ZONING COMMISSION
District of Columbia
CASE NO. 04-22A
EXHIBIT NO. 59

Re: Application for a Minor Modification to an Approved Planned Unit Development for 220 H Street, NE (Lots 802 and 803 in Square 751) – Zoning Commission Order No. 04-22

A PLANNED UNIT DEVELOPMENT

PUD MODIFICATION APPLICATION - JULY 2006

Enlarged elevation at roof
(Second Street elevation)

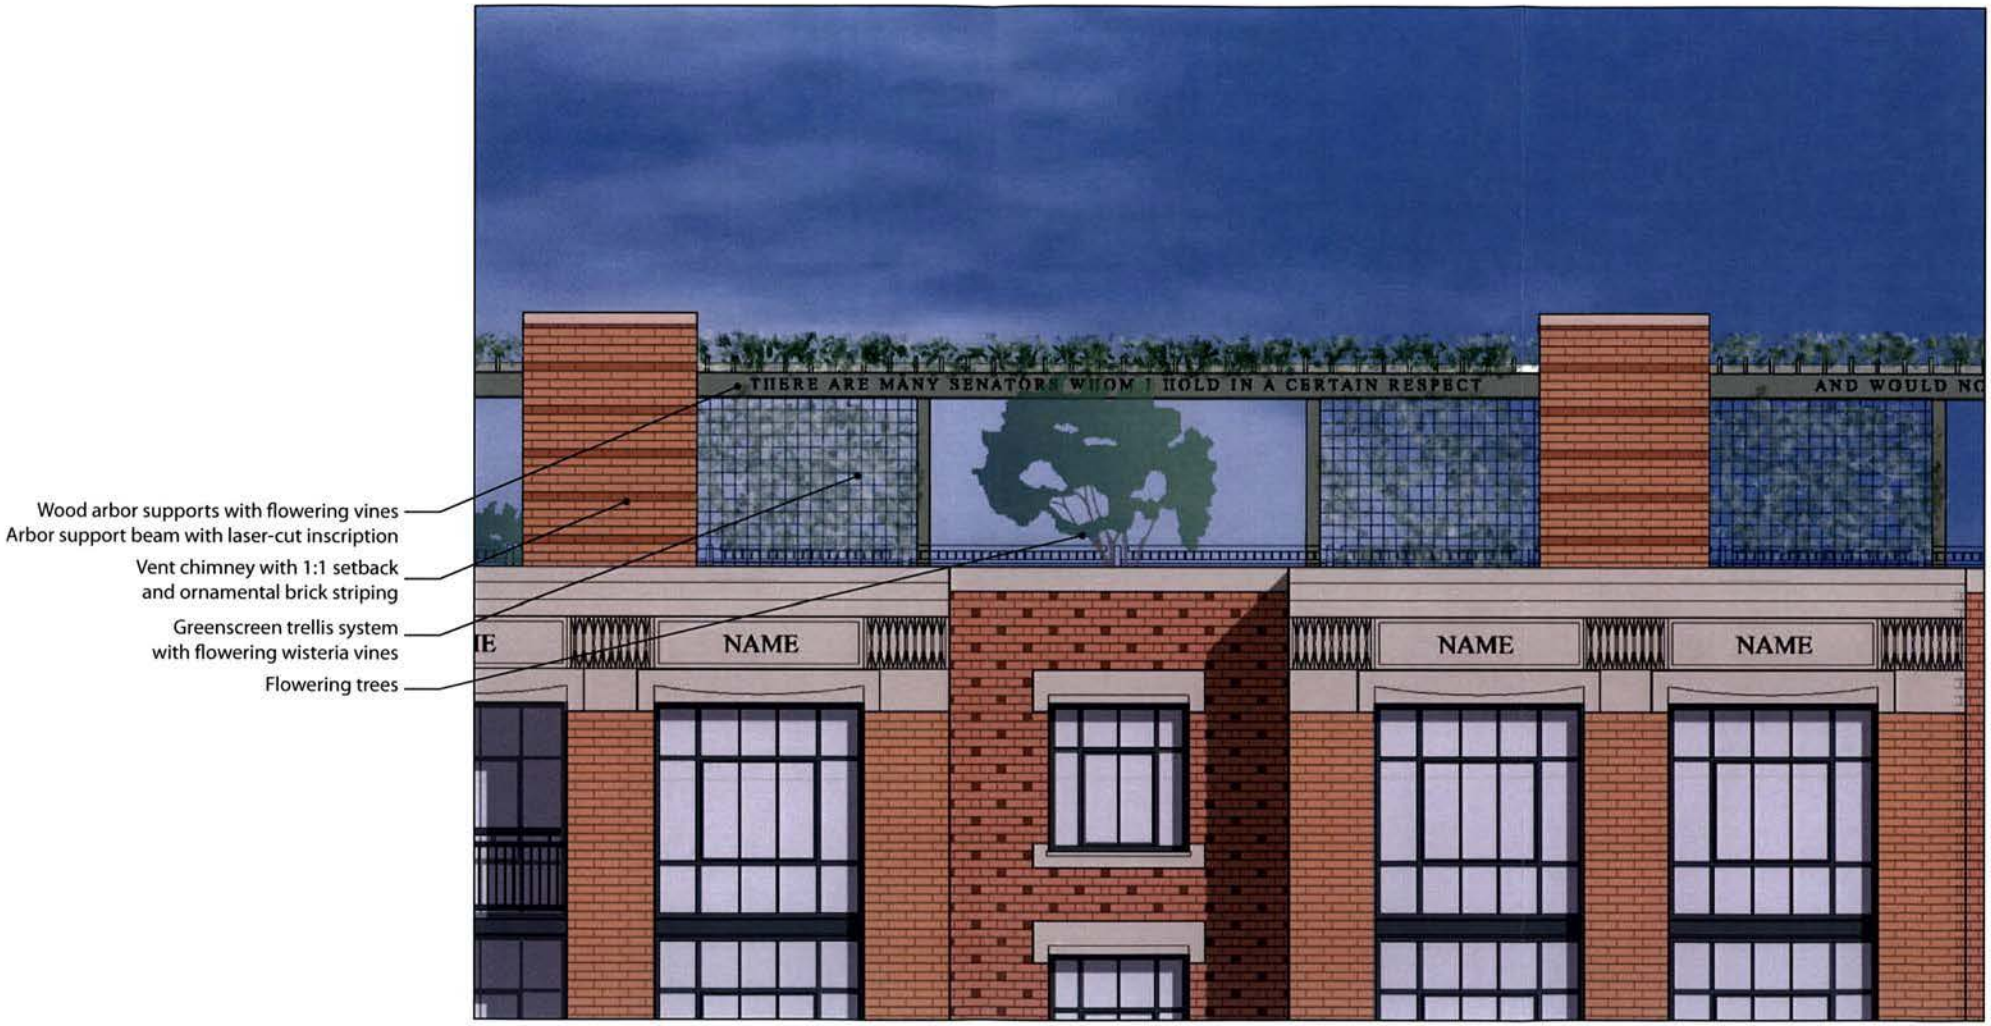
Deleted towers at I Street in favor of presence at H Street gateway
Enhanced & enlarged green roof space
Consolidation and reduction in number of vent chimneys
Brick vent chimneys with 1:1 setback
Towers at H Street bridge per 1910 Height Act
